APPENDIX D - URBAN DESIGN ASSESSMENT IN RESPONSE TO VARIOUS SUBMISSIONS

Figure 1: indicative section: Highway

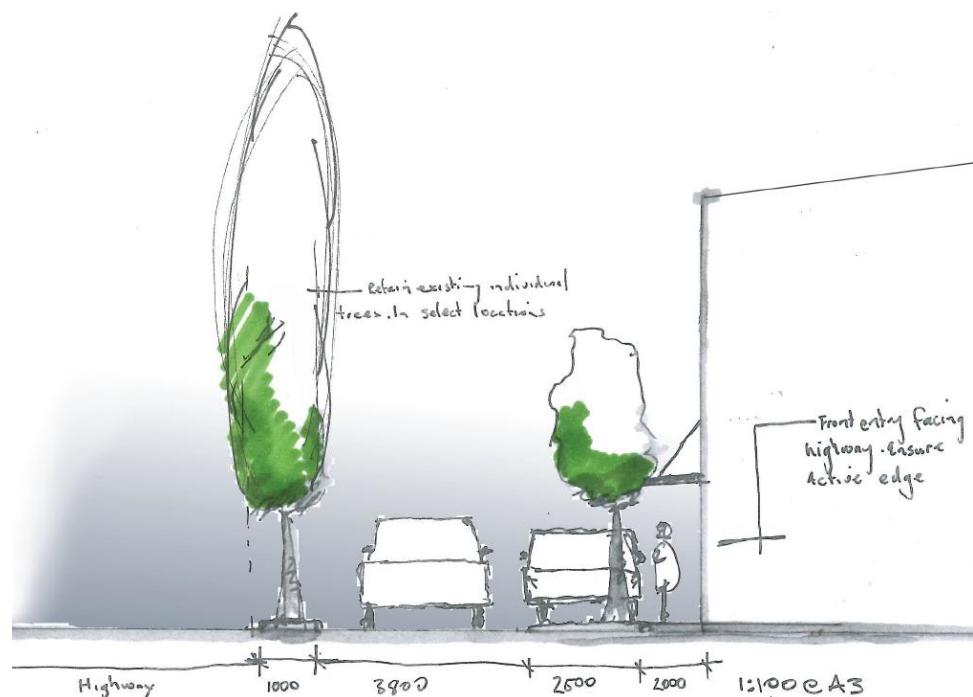
- 4.9 It is noted that the principle of using the buildings to sleeve large areas of surface car parking from the State Highway is supported and should be required in the provisions for the zone. However, more certainty in terms of achieving a successful road frontage can be provided on the site through a re-arrangement of the built form, one possible technique allowing this would be the use of a slip road/ lane within the site running parallel to the highway. Given the ability to provide street trees, footpaths, parking and a legitimate building frontage facing south, a more urban response would be developed. This could be provided without necessarily having to retain a 5 metre landscape strip, rather this space may be utilised for a small scale streetscape solution with trees, plant-outs and some parking. Such an arrangement would then provide direct access to commercial development fronting the highway where buildings would naturally front the highway rather than being forced to design a 'frontage' at the rear of a tenancy. The existing arrangement at the Frankton village illustrates an example of this and a similar approach is proposed for part of the Frankton Flats (B) zone. An indicative cross section is provided below to illustrate a possible solution where one-way traffic is provided along with parallel parking on one side.

- 4.10 In my view this type of response to the highway would provide more certainty and a better design solution than relying on a landscape setback and controls over the built form that faces the highway, when the model adopted is internally focused. Providing for car parking in a street arrangement would not in my opinion detract from the entry experience in the same manner large areas of surface car parking would. If this type of alternative approach was to be adopted it should be prescribed in the provisions for the zone.

Figure 2: indicative section: Cemetery

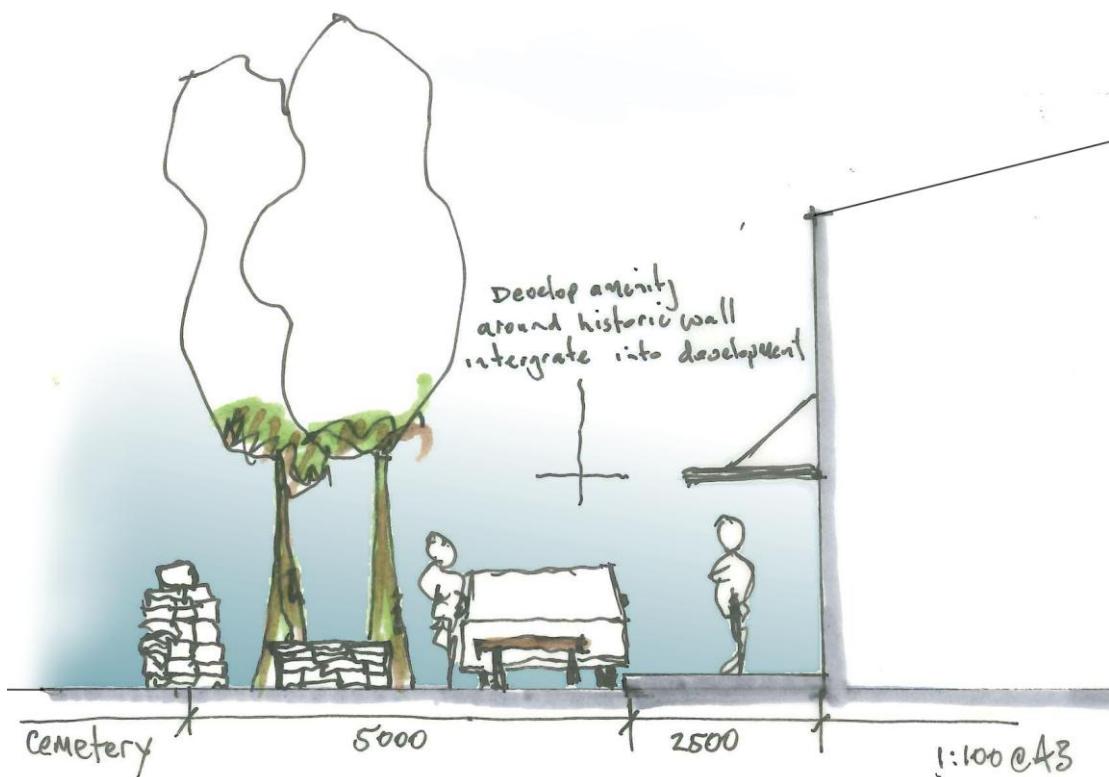
- 7.2 Providing for vehicle circulation along this boundary in a similar manner to that suggested to the highway would be one way the development could then integrate with this boundary, avoid turning its back to it.

- 7.3 The development of a space adjacent to the wall for passive recreation for residents/visitors could also utilise the character of the wall and provide the opportunity for some of the mature trees existing on the site to be retained to develop a green space that has real character and identity for future residents without being unsympathetic to needs of the cemetery. An indicative cross section is provided below to illustrate a possible solution.
